UNITED STATES PATENT AND TRADEMARK OFFICE

Office Action Summary	Application No. 10/710,454	Applicant(s) SCHMIDT ET AL.	
	Examiner KRISTINA R. FULTON	Art Unit 3673

DETAILED ACTION

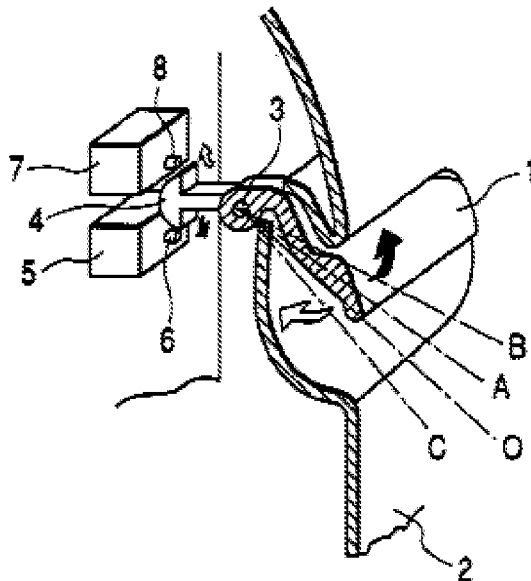
5. Regarding claims 1 and 26, Takata teaches a mechanical handle switch assembly integrated within a door of a vehicle and utilized for actuating a vehicle based system, comprising a door handle mechanism (1) coupled to a the door for actuation by a user, being movable in a substantially outboard direction for both actuating the vehicle based system and unlatching the door, a drive train mechanism (4) coupled to said door handle mechanism and being actuated by said door handle mechanism; a switch device (5) operatively coupled to said drive train mechanism and being selectively operated by said drive train mechanism to actuate said vehicle-based system. Further, Takata shows the door handle mechanism is movable within a predetermined travel distance, said predetermined travel distance including a switch-triggering distance (O-A) and an unlatching distance (O-B) that is greater than and inclusive of said switch-triggering distance (see figure below), said door handle mechanism being moved by said switch-triggering distance for actuating said switch device, said door handle mechanism being moved by said unlatching distance for unlatching the door, said unlatching distance sized greater than said witch triggering distance such that a controller can authorize

entry prior to said door handle mechanism unlatching the door. See the Takata device below.

6. Regarding claim 5, the door handle mechanism of Takata has a lift configuration for unlatching the door. See figure above.

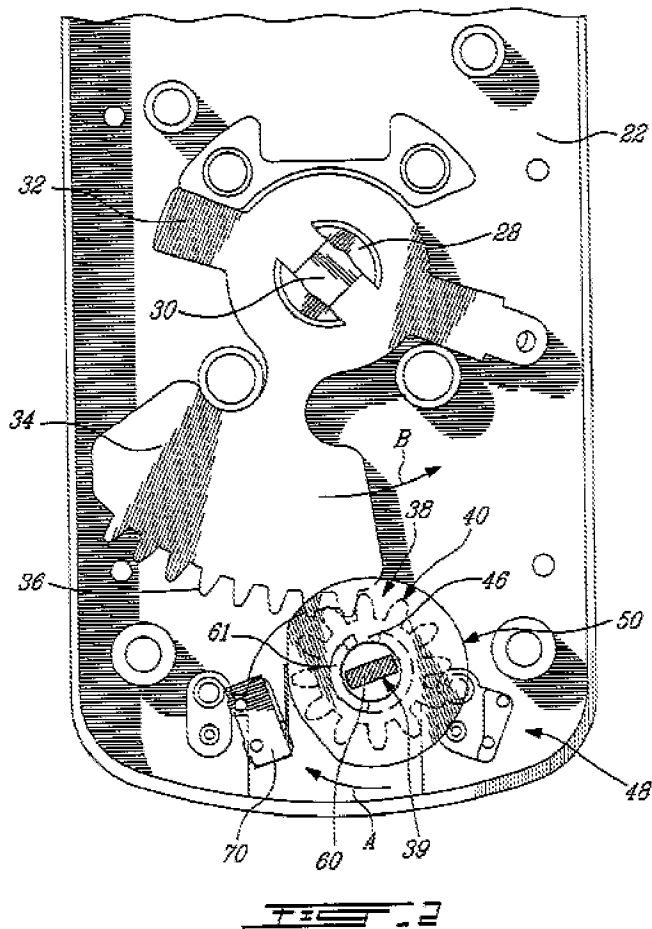
Takata fails to show a drive train mechanism including a first and second gear member and a cam mechanism. Doucet shows these features to be well known in the vehicle latch art. Doucet shows a first gear (34) having a first radius, a second gear member (40) having a second radius less than the first radius and operatively coupled to the first gear member and a cam mechanism (50) having a third radius greater than the second radius and integrated with the second gear member and directly contacting a switch device (70). It would have been obvious to one of ordinary skill in the art to replace the drive mechanism of Takata with the drive mechanism of Doucet since replacing one known element with a functional equivalent is considered to be within the level of basic knowledge of a worker in the art. Replacing the Takata drive mechanism with any drive mechanism to translate motion from the handle to the switch would be considered an

obvious modification and would yield predictable results as the drive mechanism functions in the Doucet device to relay motion to the switch as necessary in the Takata device. See the Doucet device below.
